As Built Drawing

Contract No. DACW 33-76-C-0098

4-4-83 Final field corrections		DATE	DESCRIPTION	BY
1 June 76 DMH Rim & Inv. El. revised (Am. #4)				sha
DEPARTMENT OF THE ARMY NEW ENGLAND DIVISION CORPS OF ENGINEERS WALTHAM, MASS.				
DES. BY W. F.		WATER RESOURCES DEVELOPMENT PROJECT PARK RIVER LOCAL PROTECTION BOX CONDUIT AT SECTION 2 LOW LEVEL DRAINAGE PROFILES		
SUBMITTED BY H. S.		HARTFORD CONNECTICUT		
CHIEF UTILITIES SECTION		DATE MARCH 1976		
REVIEWED BY C. P.		SCALE AS SHOWN SPEC. NO. DACW 33-76-B-0040		
PROJECT ENGINEER		DRAWING NUMBER		
APPROVED BY J. P.		PAR - 1		
CHIEF PROJECT BRANCH		SHEET 20

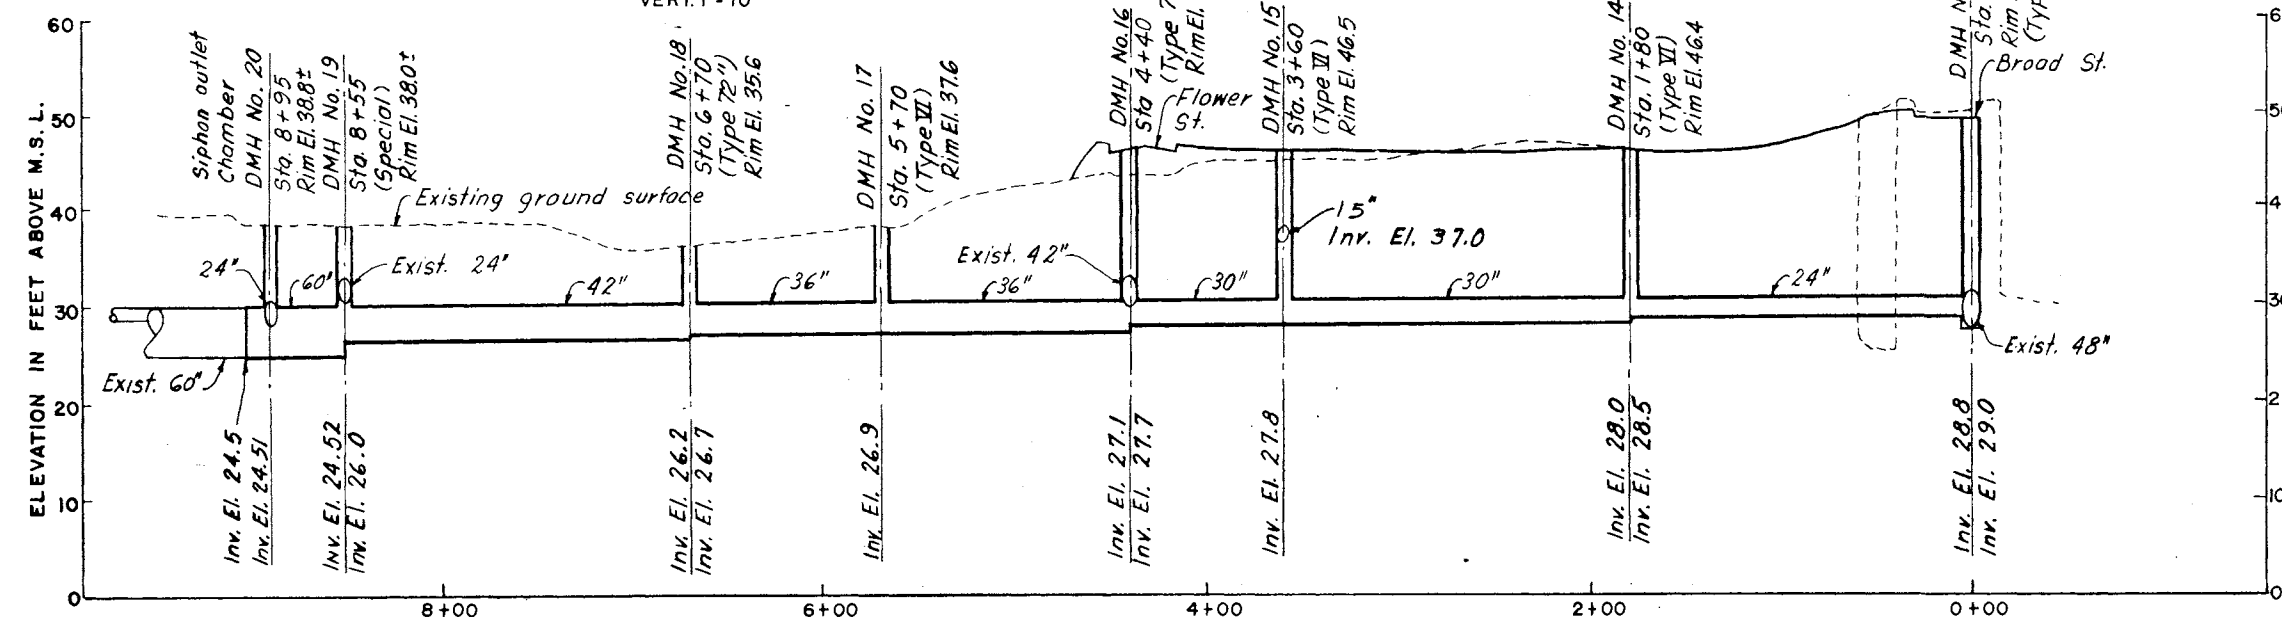
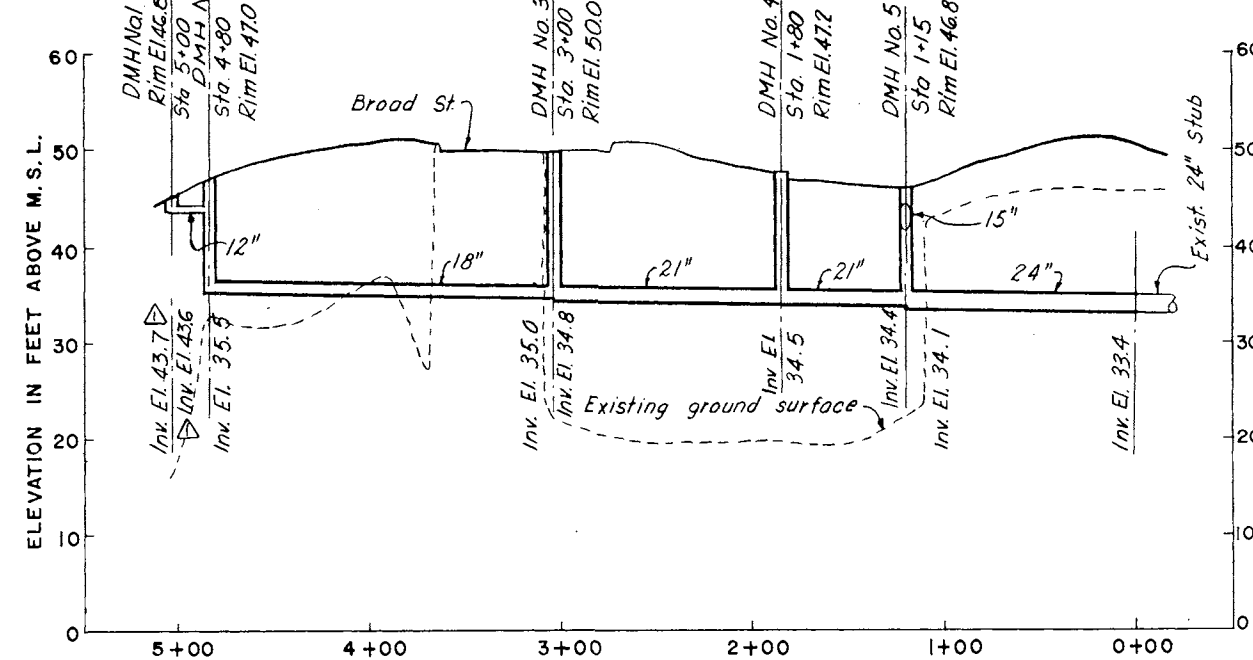
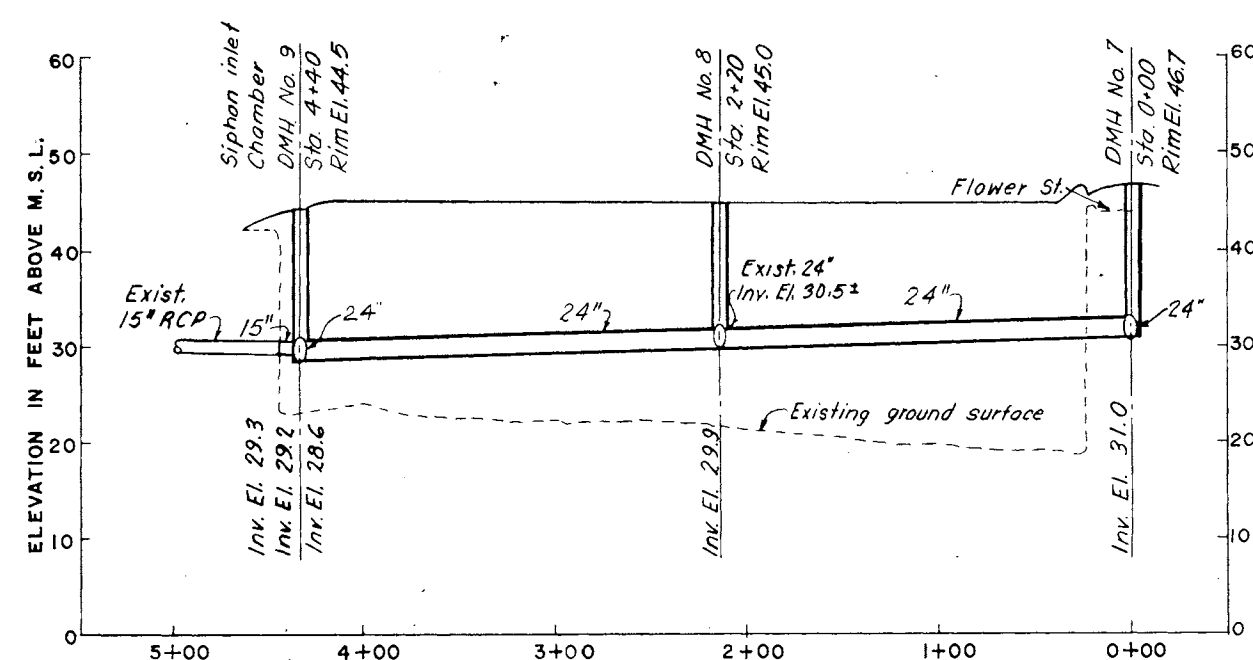
- NOTE:**
1. For location of low level drains see sheets 18 and 19.
 2. All manholes shall be Type II unless otherwise noted.
 3. DMH Nos. 13, 16 & 18 changed from Type II to Type I.
Top slabs, with 48" risers, installed on DMH bases Nos. 13 & 18.
